Our ref: UAM-NRC-06-004

Subject: Docket 71-9239, Request for Revision to Certificate of Compliance USA/9239/AF

Westinghouse Electric Co. hereby submits an application for revision to the Certificate of Compliance No. 9239 (Docket 71-9239) for the Model Nos. MCC-3 and MCC-4 shipping packages. The requested revision involves modifications to the package contents. There have been no design changes made to the packaging. This revision to the Certificate of Compliance is needed to support fuel deliveries in July 2006.

Figure 1 Evaluation with no added absorbers for enrichment in U-235 4.65 to 5.00 wt. %

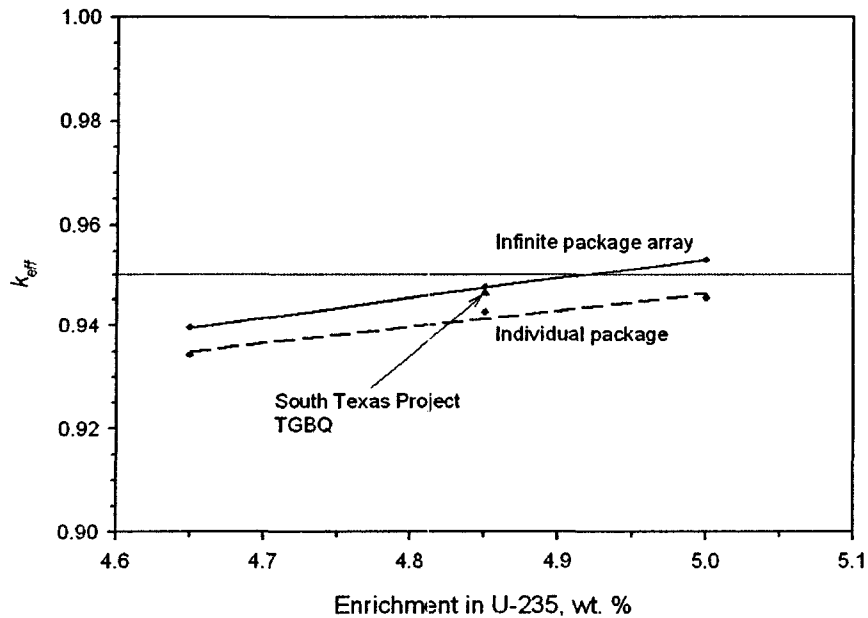
The 17XL (STD) type fuel assembly enrichment in U-235 may be increased above 4.65 wt.% up to 4.85 wt.% in the MCC package without the optional Gadolinia plate. The maximum calculated keff for an infinite array of MCC packages with a 17XL type fuel assembly enriched in U-235 to 4.85 wt. % is 0.9475. The actual South Texas Project fuel assembly TGBQ at 4.85 wt.% with 7 inch 2.60 wt. % annular pellet blankets is 0.9462.

The difference in keff for an individual package and infinite package array is less than 0.005 Δkeff, and this difference is not considered significant enough to evaluate finite package arrays as an option for increasing the maximum allowed enrichment beyond 4.85 wt. % in the MCC package with no horizontal Gadolinia plates. The MCC package may be used to transport 17XL type fuel assemblies without the optional horizontal Gadolinia plate up to 4.85 wt. % enrichment in U-235, and the current criticality safety index (CSI) equal to 0.4 may still be used.

The 17XL with no added absorbers, "single Gd plate", is evaluated at 4.85 wt.% and 5.00 wt.% and the results summarized in Table 2 and Figure 1.

Modify Paragraph 6 the Certificate of Compliance for package identification number USA/9239/AF to allow the 17X17 STANDARD lattice fuel assemblies (17X17 STD and 17X17XL) contents to be shipped in an MCC-3 or MCC-4 without the optional horizontal Gadolinia plate installed for enrichments up to and including 4.85 wt%.

(b) For shipments of 17x17 STANDARD lattice fuel assemblies (17X17STD and 17X17XL) with U-235 enrichments of over 4.85 and up to 5.0 wt%, horizontal Gd<sub>2</sub>O<sub>3</sub> neutron absorber plates shall be positioned underneath each assembly. The horizontal absorber plates shall be placed horizontally on the underside of the strongback, as specified in the respective drawing in Condition 5(a) for the MCC-3 and MCC-4 models.
